## SB, Updated blade guard, FS305, FS309, 2017-04

Figure 1: New blade guard design left, old design to the right.

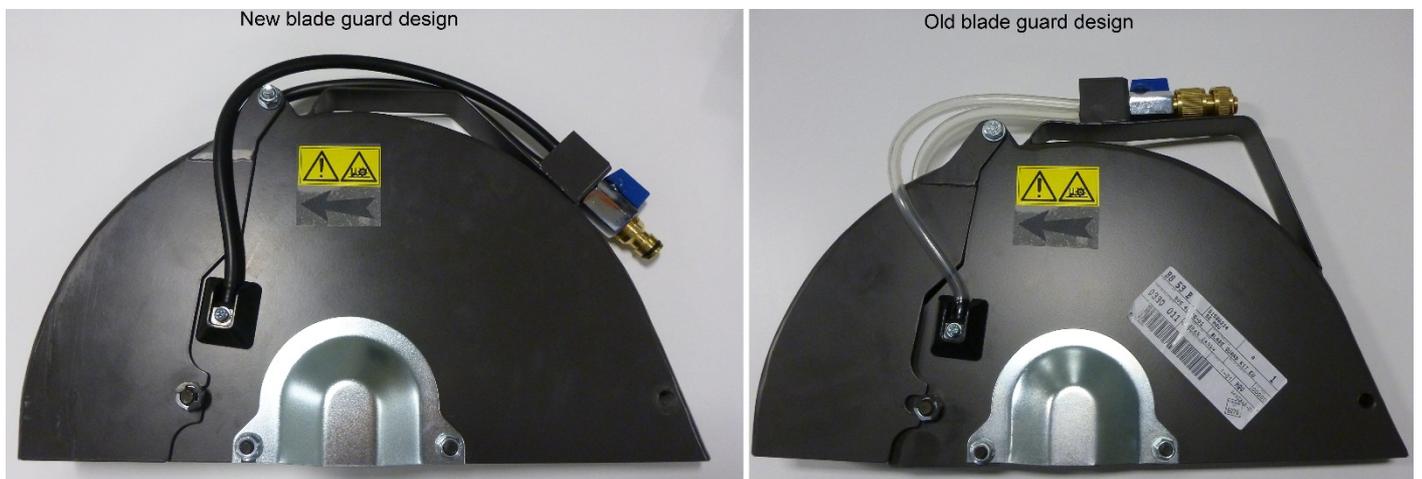
The blade guard for FS 305 and FS 309 has been modified to get the same design on all markets and to achieve a more robust watering system.

Blade guard changes:

- Minor design changes to front, back and side cover parts.
- Water valve moved backwards.
- Hose material changed and hoses made longer.

The new blade guard design is implemented in production from serial number: **2016 4000018**.

Figure 2: Illustration of new blade guard from spare parts list.

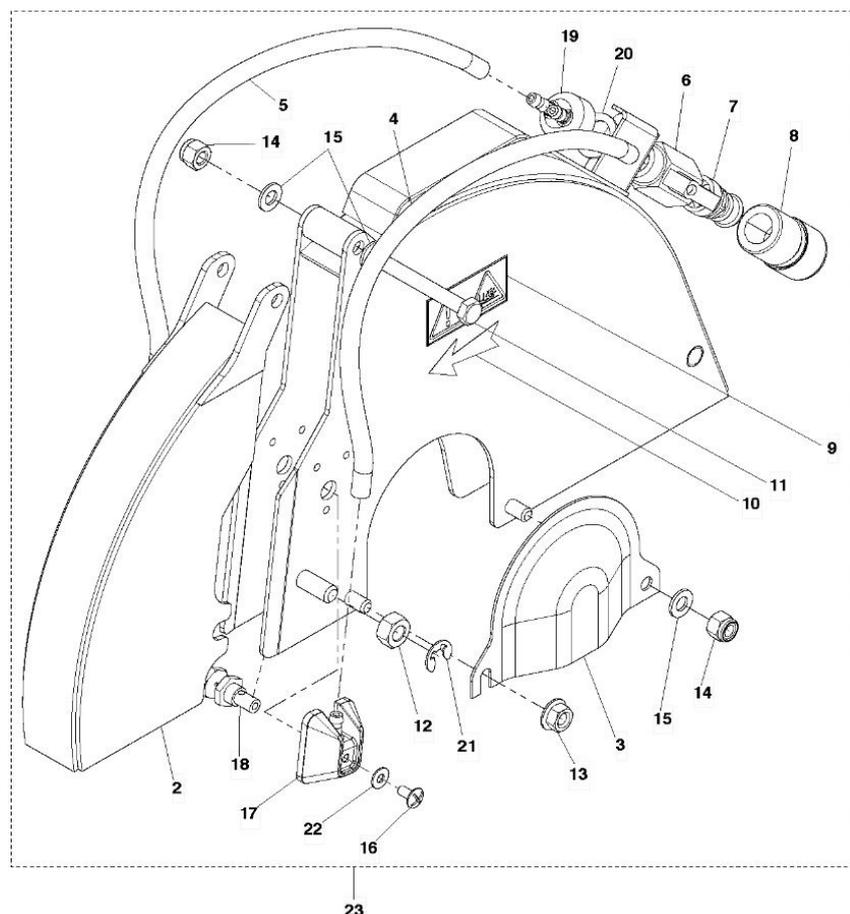
Description	Pos. in figure 2	New part no.	Old part no.
Complete blade guard assembly	23	579 80 10-01	505 42 46-01 * (US version) 543 08 41-39 * (EU version)
Water hose	4 / 5	588 81 99-01	543 04 55-77 *
Front blade guard	2	579 80 12-01	505 41 54-01 * (US version) 501 97 65-01 ** (EU version)
Cover plate	3	579 80 24-01	543 08 23-17 *

\*\* The old front blade guard part EU version is not compatible with the new blade guard design and is therefore terminated. Order complete blade guard instead (579 80 10-01).

\* New and old parts are compatible. Use up old parts in stock and then supersede with the new part number.
